Staff Summary Report

SUBJECT: Hold a public Hearing for a General Plan Amendment, Zoning Map Amendment, Use Permit, Development Plan Review and Subdivision Plat for PHOENIX PUMPS located at 1212 North McClintock Drive.

COMMENTS: Request by **PHOENIX PUMPS (PL090460)** (Don Vise, Phoenix Pumps Inc, property owner; Michael Jorgensen, Cawley Architects, applicant) consisting of a two story building containing light manufacturing, office and warehouse functions of +/-36,018 s.f. on a +/- 2.27 net acre site and located at 1212 North McClintock Drive in the CSS, Commercial Shopping and Service District, the GID, General Industrial District and the RSOD, Rio Salado Overlay District. The request includes the following:

PREPARED BY: Kevin O'Melia, Senior Planner (480-350-8432)

EXTERIOR ELEVATIONS
 3/32" = 1'-0"
 0 10 20

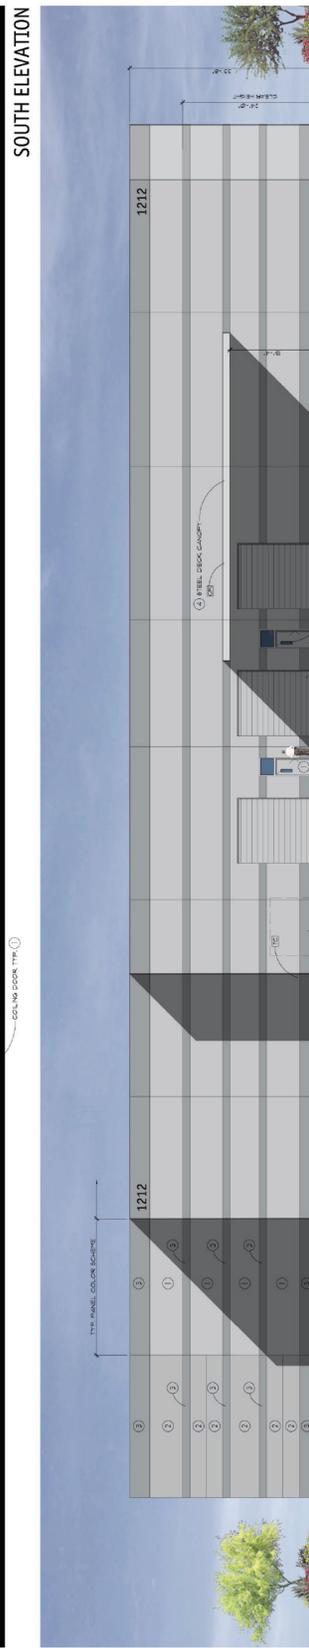
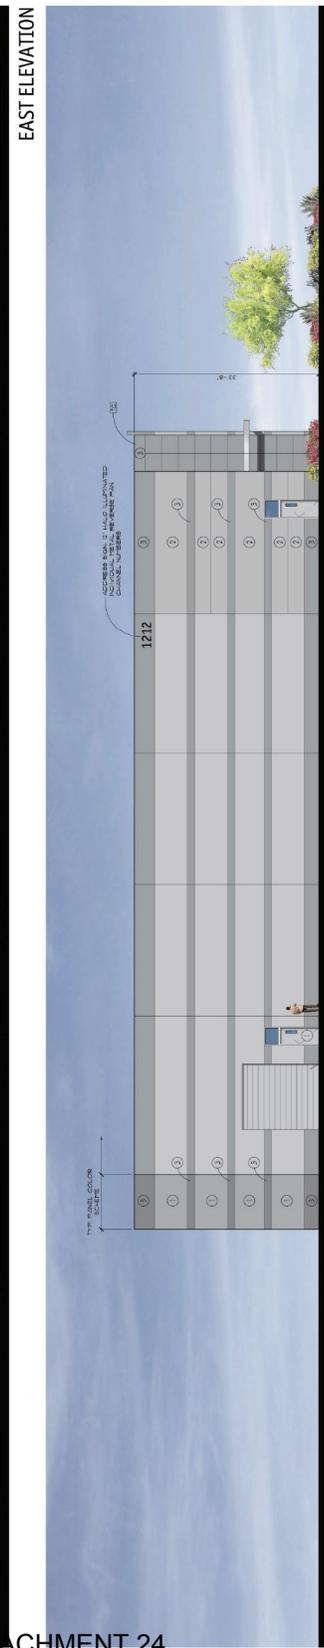
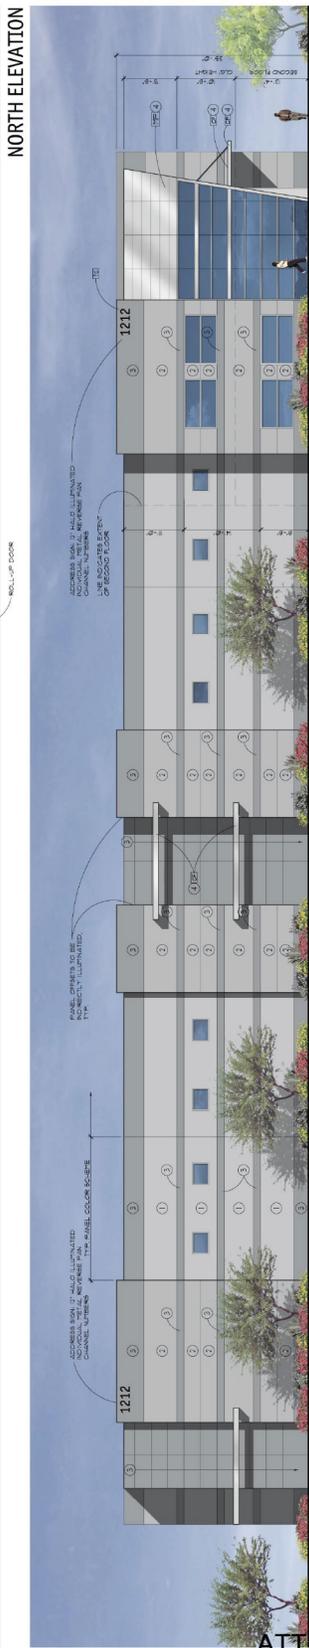
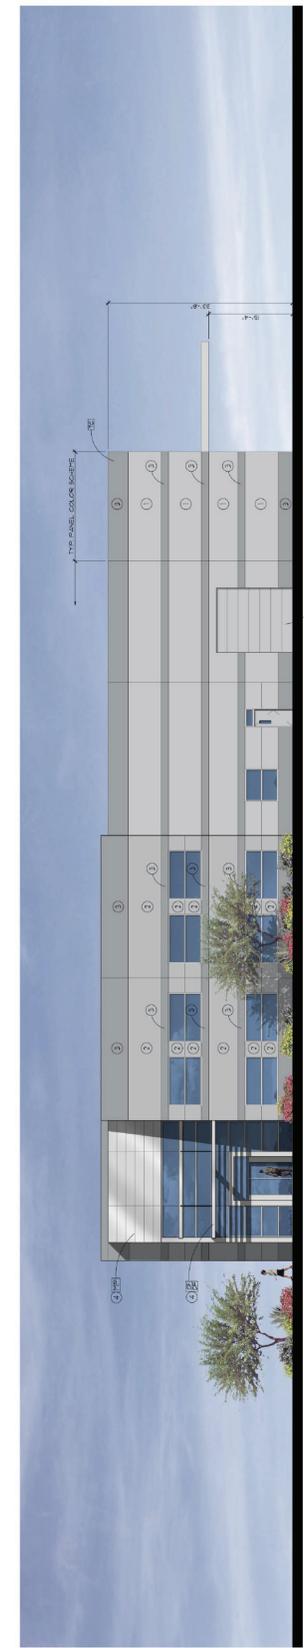
- 1) add north and south fenestration alcoves to the east elevation, and
 - 2) add simple planar protrusions to the east elevation to enhance the volumetric interest of the building.

- c. Keep the main tilt-slab wall plane of the east elevation at a 25.0 ft. setback on the street side yard.
9. The Use Permit Standard, if approved, shall be in effect only for the length of time of the Development Plan Review approval.

37. Provide major address signs on the building elevations on the west, south and east building elevations in locations indicated on Exterior Elevations sheet A7.1. Additionally, provide major address sign on each side of base of freestanding sign.

THESE PLANS ARE NOT APPROVED FOR CONSTRUCTION WITHOUT AN APPROVED PERMIT FROM THE GOVERNING JURISDICTION.
 THE JOB NO.: LGE0104
 SCALE: 1" = 20'
 SHEET: C1

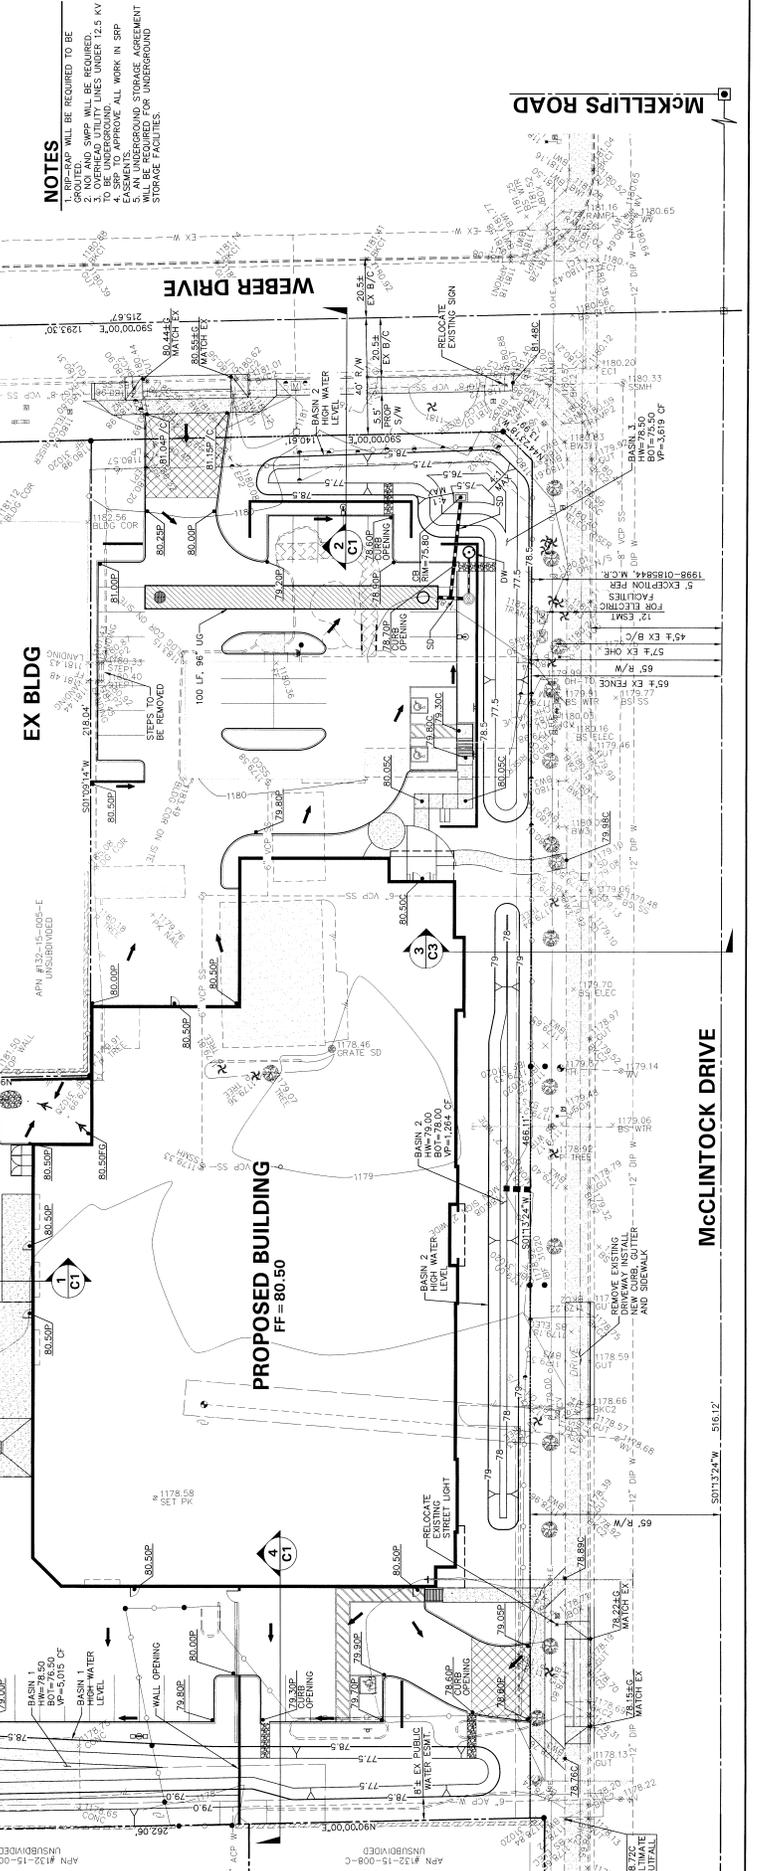
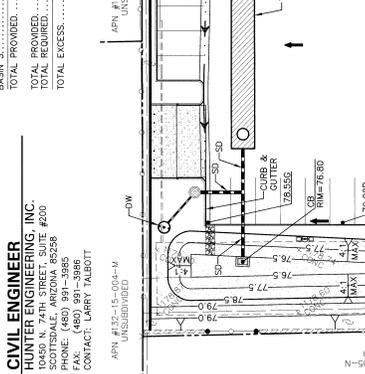
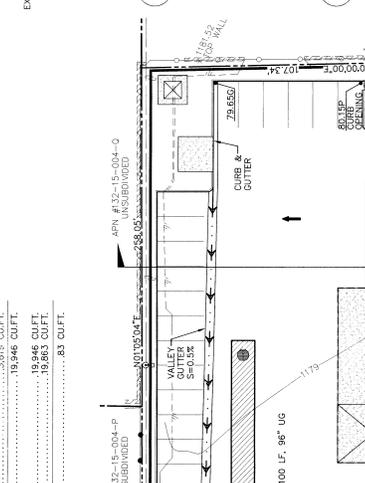
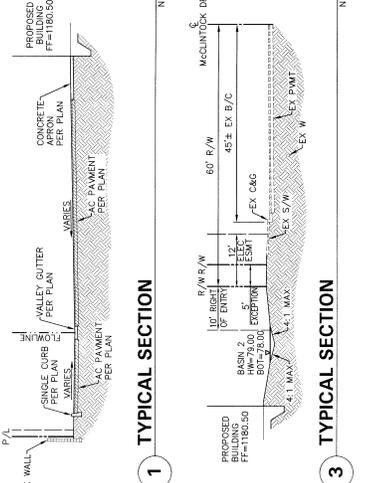
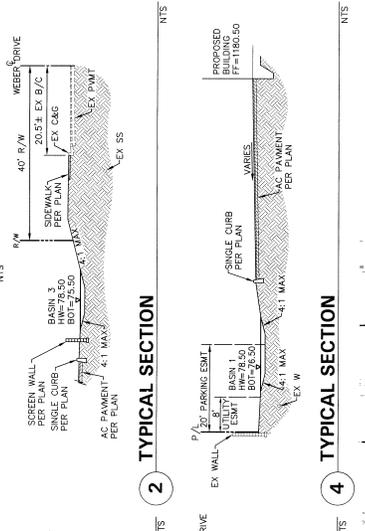
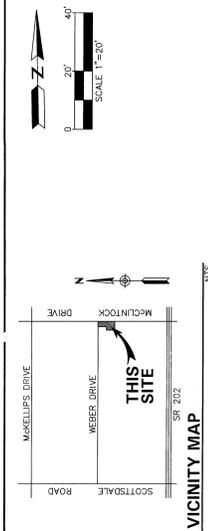
12. Inside the gated service yard, paint the required fire lane including the hammerhead turnaround southwest of the building and the fire lane extension on the west side of the building. Match the layout indicated on the Preliminary Site Plan Review mark-up, sheet A1.1, dated October 20, 2010.

17. Remove chain link fence and razor wire where exists on-site.
18. Provide upgraded paving at each driveway apron consisting of uncolored cast in place concrete. Extend concrete paving in the driveway from the back of the accessible public sidewalk bypass to minimum 20'-0" on site and from curb to curb at the drive edges.
